## DEFENSE NUCLEAR FACILITIES SAFETY BOARD

November 12, 2019

## LOS ALAMOS NATIONAL LABORATORY PLUTONIUM FACILITY LEAK PATH FACTOR METHODOLOGY

### Defense Nuclear Facilities Safety Board Technical Report

**Figure 1.** An example taken from a LPF array for the post-seismic fire accident scenario.

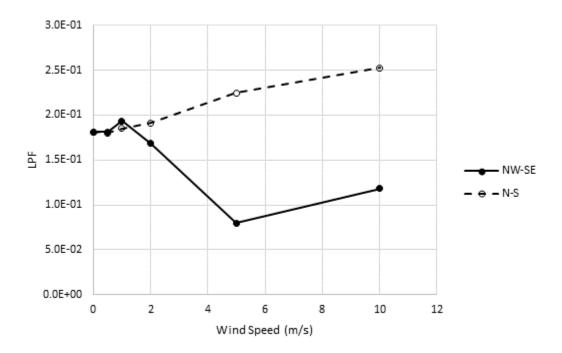
Non-physical Behavior in LPF Arrays—The staff team identified instances where the LPF arrays provided by LANL exhibited seemingly non-conservative or non-physical behavior. Although wind speed and LPF are expected to be correlated, the staff team identified instances where the LPF did not increase with wind speed. Figure 1 shows an example of such an instance where the LPF in the north-south direction (represented by the dashed line) increases monotonically with wind speed. Conversely, the LPF in the next sector, northwest-southeast (represented by the solid line), generally decreases.

The staff team's discovery that the LANL calculations in some cases yield decreasing LPF values with increasing wind speeds reveals two potential non-conservative aspects in the calculations:

- LANL personnel stated that using LPF values in high percentiles in combination with the 95<sup>th</sup> percentile of  $\chi/Q$  is non-physical and overly conservative because LPF values and  $\chi/Q$  values are inversely proportional. However, if the LPF decreases with increasing wind speed, then  $\chi/Q$  and LPF are not always inversely proportional and higher percentile LPF and  $\chi/Q$  values may simultaneously exist for the same weather data. Therefore, it may not be overly conservative to use LPF values in higher percentiles with the 95<sup>th</sup> percentile of  $\chi/Q$ .

- LANL personnel stated that one of the additional conservatisms in the statistical methodology is that hourly wind speed values are rounded up to the next highest wind speed in the LPF array when interpolating LPF values. For instance, if a given hourly wind speed was 3 meters per second (m/s), then the LPF selected for that hour would

correspond to the LPF array at 5 m/s. Since there are cases where LPF values decrease with increasing wind speed, then rounding up to the next highest wind speed is not always conservative.

**Figure 2.** An example taken from a LPF array for the vault fire accident scenario.

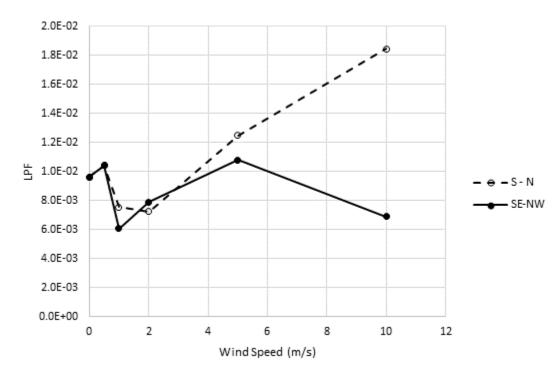
Additionally, the staff team identified instances where the LPF arrays exhibited potentially non-physical behavior, which casts doubt on the validity of the LPF values used in the DSA. Figure 2 shows an example of potentially non-physical behavior where both the southnorth (represented by the dashed line) and southeast-northwest (represented by the solid line) directions track reasonably well from 0–5 m/s, then diverge after 5 m/s. Additionally, both the south-north and southeast-northwest directions have local maxima at 0.5 m/s, then decrease, then increase again.

During onsite discussions, LANL personnel were unable to explain the anomalous behavior but stated their intention to better understand the behavior through updated LPF modeling efforts. The staff team concludes that the erratic behavior of the LPF arrays indicates weaknesses or inaccuracies in the MELCOR and CFD modeling, and that such inaccuracies indicate that the LPF values may not be defensible.

**Figure 3.** *Leak path factor software packages and modeling progression.*

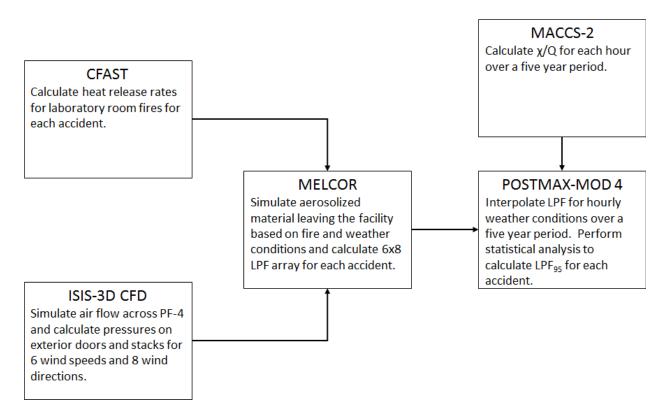
To determine the appropriate pressure boundary conditions to assign to the external doors in the PF-4 MELCOR model, LANL subcontracted Alion Science and Technology, Inc. (Alion), to perform a CFD analysis of air flow across PF-4 [9]. Alion personnel used the ISIS-3D CFD code on a realistic model of PF-4 that includes attached performance category 3 structures. They performed steady state calculations for six uniform wind speeds and eight wind directions and reported area-averaged static pressures for different locations across the exterior of the building. LANL personnel used these results to set pressure boundary conditions for external doors and stack exhausts in the MELCOR model. During its review, the staff team noted differences between the values reported in the CFD report and those listed in the MELCOR boundary condition files. During onsite discussions, LANL personnel indicated that they also were unable to determine how the CFD-derived pressures were applied as boundary conditions in MELCOR. The MELCOR pressure boundary conditions are an important input to the model that strongly influences how much material is driven out of the building during an accident.

Additionally, the ISIS-3D CFD code is not classified as safety software, which would require software quality assurance activities like software verification and validation.

Furthermore, Suo-Anttila, et al. [10], describe the code as "currently <u>under development</u> for the Defense Threat Reduction Agency (DTRA) as a tool for risk assessment and engineering level analysis [emphasis added]." The Alion report provides limited validation of the code for a simplified geometry but does not discuss any software quality assurance activities to support the complex modeling of the PF-4 facility.

LANL personnel informed the staff team that they intend to improve documentation associated with the LPF calculation as part of the LPF upgrade. LANL personnel also noted that they plan to use the ANSYS Fluent CFD software package to model the air flow across PF-4, with appropriate commercial grade dedication of the software. LANL plans to follow the same statistical methodology for calculating the LPF<sub>95</sub> as described above in this planned update.

**Figure A-1.**  $LPF_{95}$  and  $\langle LPF \rangle_{95}$  within the five-year LPF distribution for Fire in Robotic Calorimetry Room.

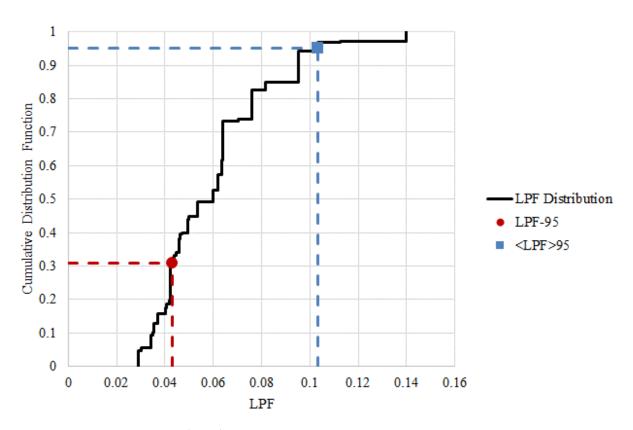
As an example of how these values and distributions compare, Figure A-1 shows the five-year cumulative distribution function of the LPF for the Fire in the Robotic Calorimetry Room accident scenario, with the LPF<sub>95</sub> and  $\langle LPF \rangle_{95}$  identified.

**Figure C-5.**  $R^2$  values from 15- versus 60-minute and 30- versus 60-minute wind data extrapolated to five minutes.

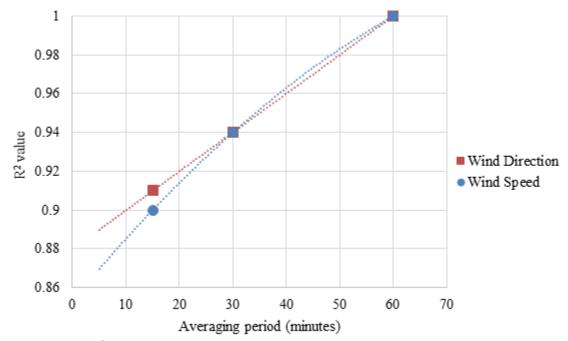
The staff team used polynomial extrapolations to estimate the five-minute  $R^2$  values because three data points were available. The extrapolation of the  $R^2$  values in Figure C-5 estimates the five-minute  $R^2$  values to be 0.87 for wind speed and 0.89 for wind direction.

**Figure C-6.** Percentage of comparisons of 15- versus 60-minute and 30- versus 60-minute data meeting or exceeding criteria of one-sector difference or given percentage speed difference, extrapolated to five minutes.

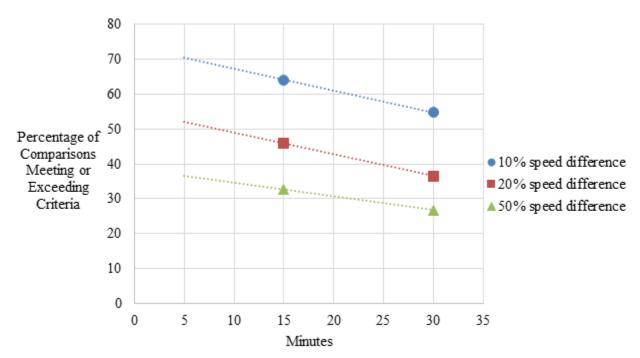
The extrapolation to five minutes from Figure C-6 estimates that 70 percent of comparisons between five- and 60-minute wind data are different by at least one sector or have a difference in wind speed of at least 10 percent. Similarly, 52 percent of five- and 60-minute comparisons are different by at least one sector or have a wind speed difference of at least 20 percent. Finally, 37 percent of five- and 60-minute comparisons are different by at least one sector or have a wind speed difference of at least 50 percent. Due to the high frequency of significant differences between the five-minute average wind data and the 60-minute average

wind data, the staff team concludes 60-minute average wind speed and direction values are not appropriate representations of the five-minute LPF phenomenon.
